### **DRAWING CHANGES**

### REMARKS

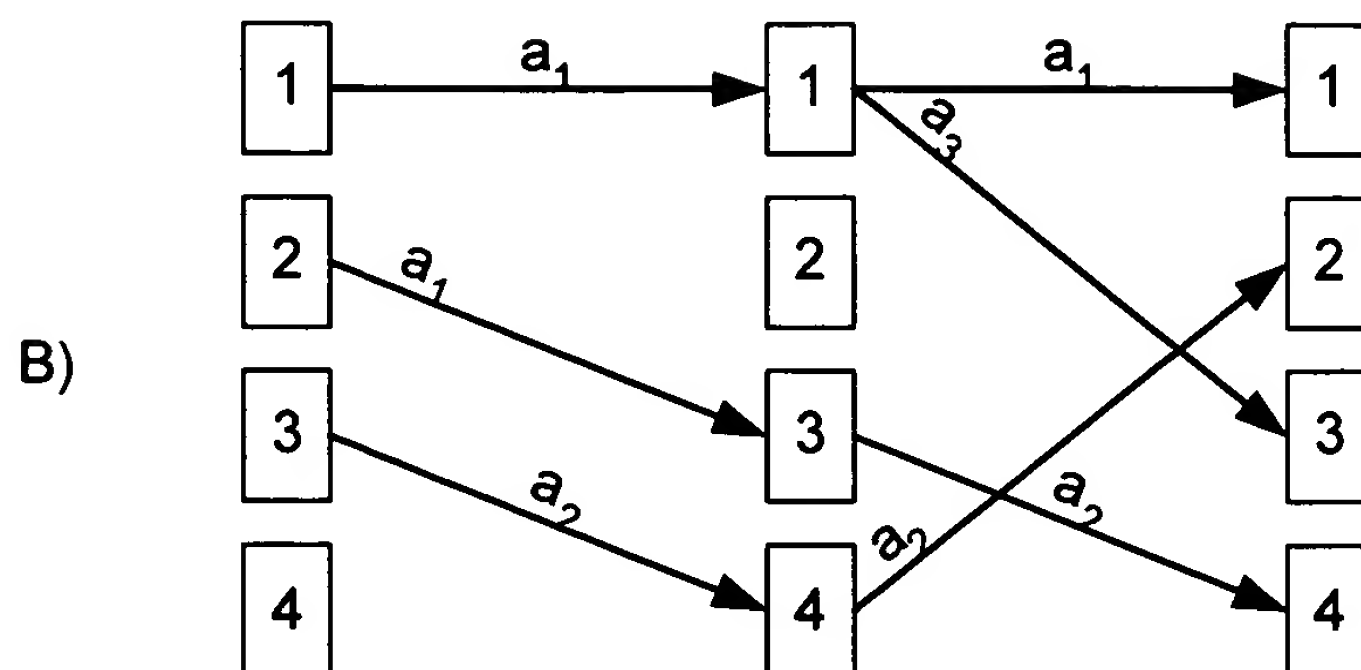
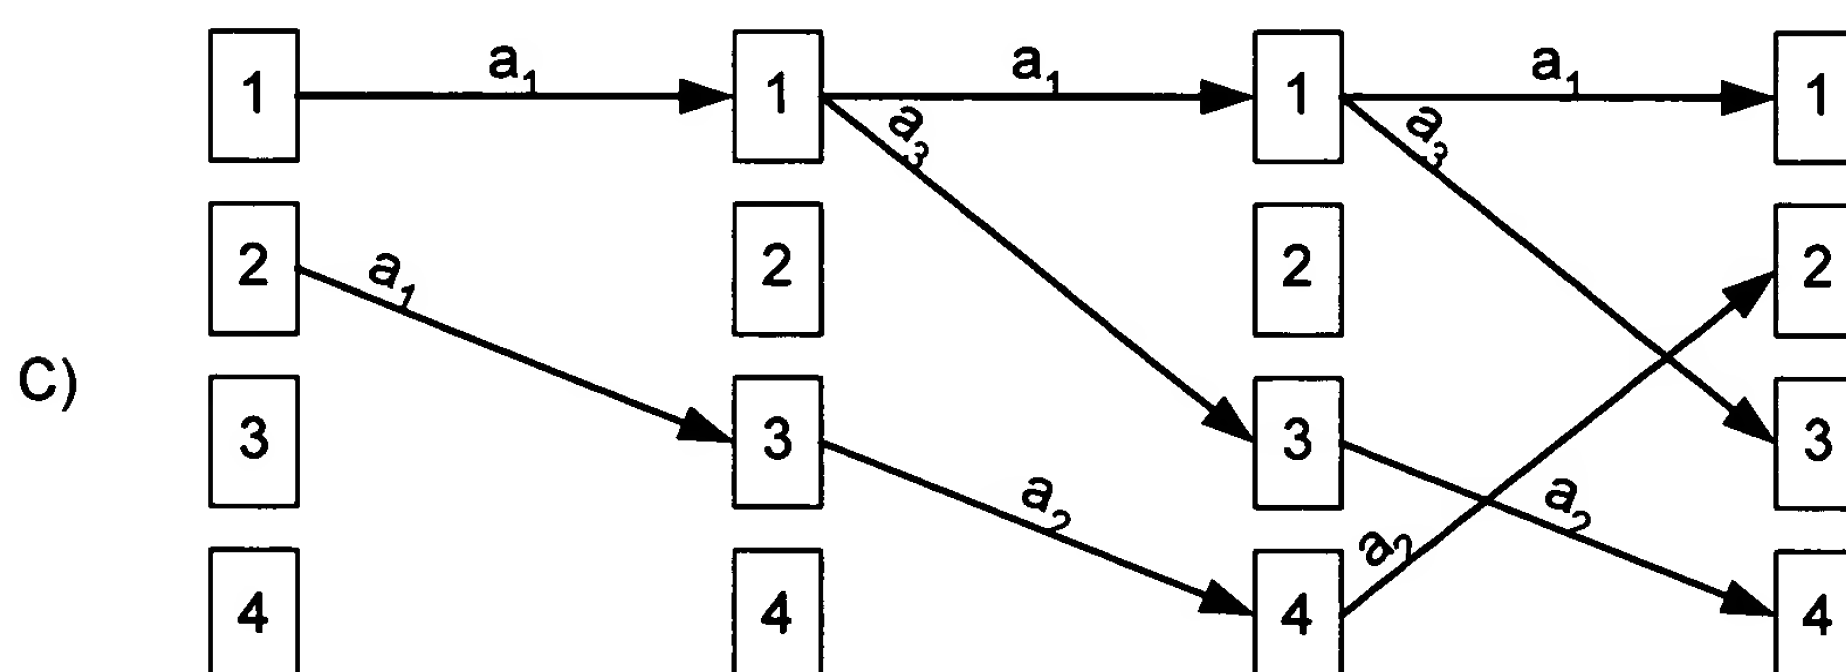
In the second pass, the second element is analyzed in a similar way. However, the elimination step now includes the previous trellis as shown in Fig. A) Again, all distances are calculated and then the resulting distances through the two-step trellis are used and the shortest distances determine the transitions that are kept. Thus, in this example, the transition from state 3 to state 2 in Fig. A is eliminated. The result is shown in Fig. B).

The last pass repeats these steps for the last symbol. The elimination process affects the previous two trellis by eliminating the transitions from state 3 to state 4 to state 2 in Fig. B). The resulting three-way trellis is shown in Fig. C) below:

FIG. 1  
(PRIOR ART)

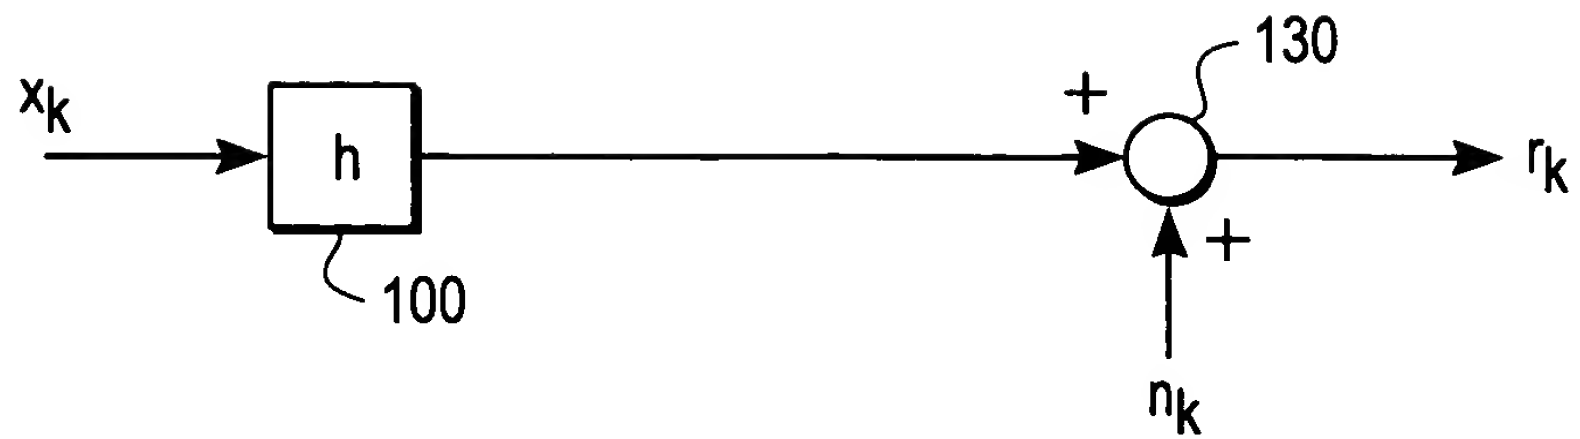
Examiner has objected to the drawings for not showing every feature of the invention specified in the claims under 37 CFR 1.83(a). Applicant submits corrected drawings in compliance with 37 CFR 1.121(d). Figures 1 and 2 have been identified as prior art. Applicants have also reordered the drawings so that Fig. 2 is below Fig. 1 instead of Fig. 7.

The Examiner has objected to the drawings for not showing every feature of the invention specified in the claims under 37 CFR 1.83(a). Applicant submits corrected drawings in compliance with 37 CFR 1.121(d). Figures 1 and 2 have been identified as prior art.
